Product / Process Change Notification (PCN)

PCN #: PCN_ConFSH_20200901

Affected Series: WR-FSH-
 696309001002
 696309001102
 696310001002

696310001002 :

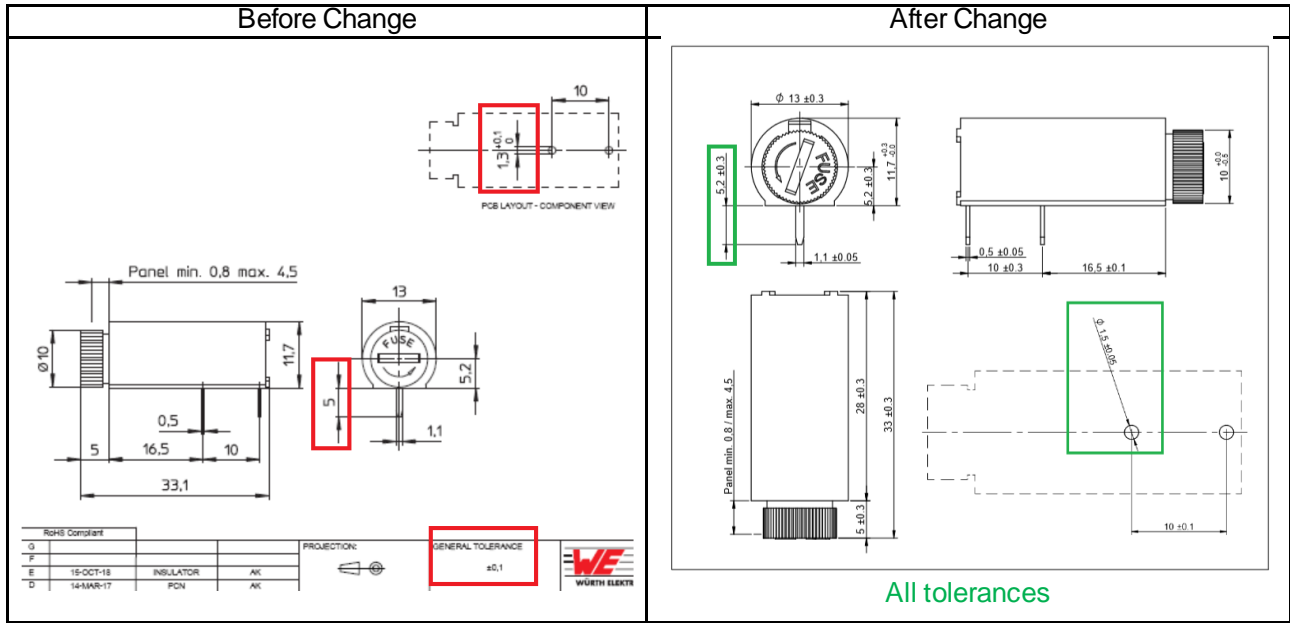
Corrected dimensions and tolerances are marked with a red box before and green box after change.
